# TANDBERG TAPE RECORDER INFORMATION

No. 104  
Oslo, 2nd December 1970

## Series 3000X/6000X

### Modified take-up clutch

Bottom view of take-up turntable and friction disc.

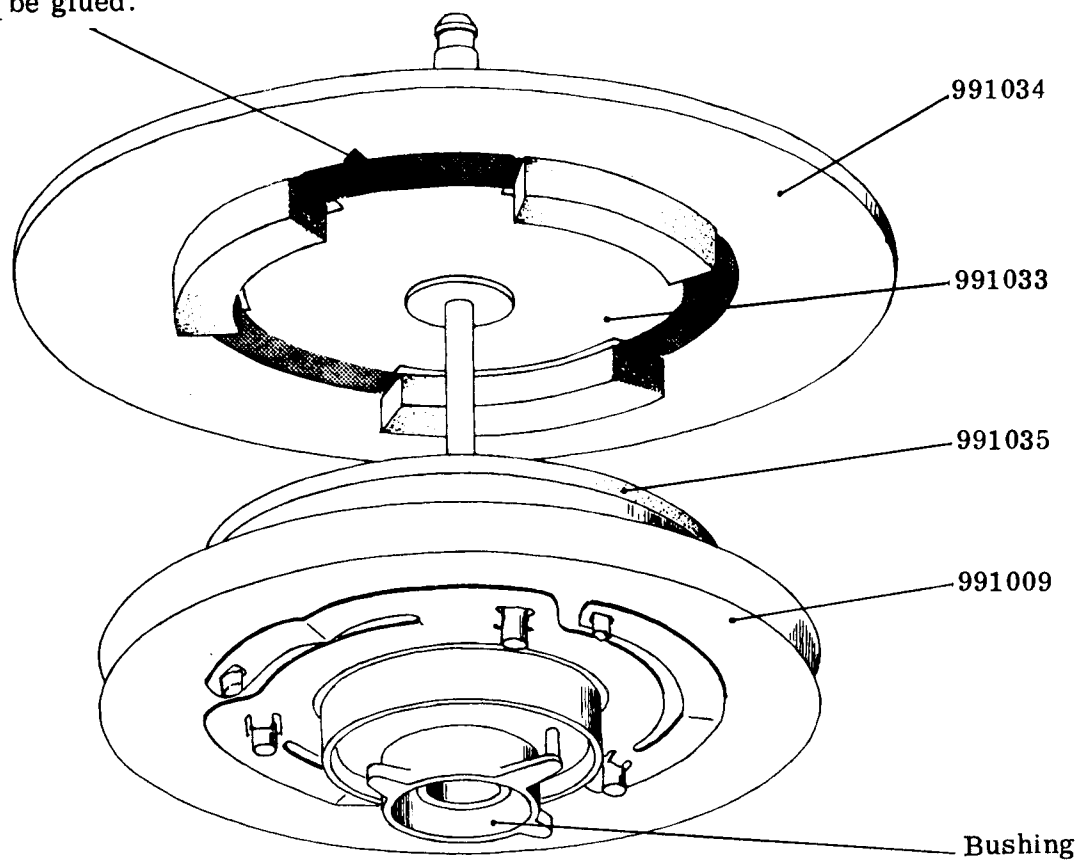
The materials originally used in the take-up clutch have after prolonged operation in hot environments in some cases shown a tendency of excessive wear.

Clutch components in a better material were introduced in production from the following serial numbers:

In some units, the bushing in the friction disc has a wide flap instead of a small stud to prevent rotation. The bushing with the flap can be snapped out of the bearing by means of a screwdriver and must be installed in the new friction disc to facilitate the rest of the assembly

The hatched areas indicate the adhesive coating holding the friction pads. The mylar sheet must not be glued.

The same parts are available as service kits comprising:

1 ea take-up turntable with friction  
pads, and mylar sheet with felt part No. 991034

1 ea take-up friction disc with  
coupling disc, spring, ball bearing  
and bushing part No. 991009
